Product Discontinuance Notification — PDN # 0000283776
19 October 2018

MAR-2000 Series phase out notice.

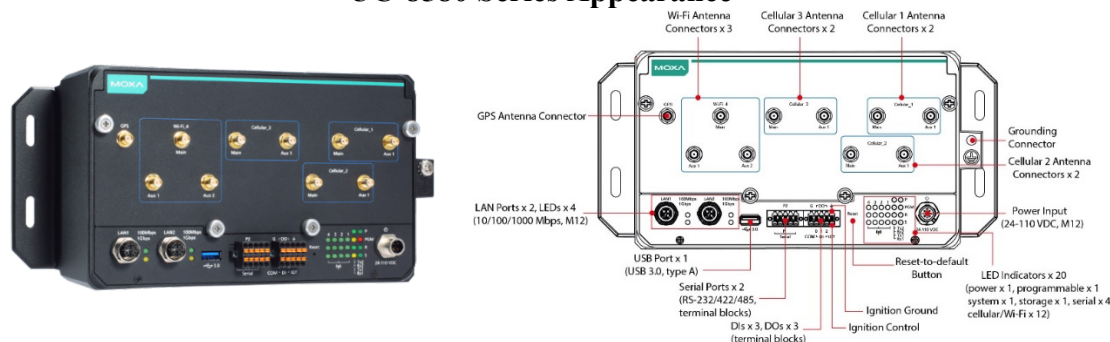
Moxa will build multiple enhancements and features into the new UC-8540/UC-8580 Series, which is the recommended replacement for the MAR-2000 Series. Please refer to the following tables and diagram for a comparison of the enhancements to the UC-8540/UC-8580 Series as compared with the MAR-2000 Series and the possible impacts this may have on your systems:

Category	Subcategory	Enhancements in the UC-8540/UC-8580 Series
Form factor	Housing	1. Rugged housing 2. Single-panel (top panel) I/O design
	Dimension	3. Redesigned for better maintainability MAR-2000 Series: 200 x 57 x 120 mm (7.87 x 2.24 x 4.72 in) UC-8540: 160 x 120 x 120 mm (6.30 x 4.72 x 4.72 in) without wall-mount ears 190 x 120 x 125 mm (7.46 x 4.72 x 4.92 in) with wall-mount ears UC-8580: 220 x 134 x 88 mm (8.66 x 5.28 x 3.46 in) without wall-mounting ears 270 x 134 x 88 mm (10.63 x 5.28 x 3.46 in) with wall-mounting ears
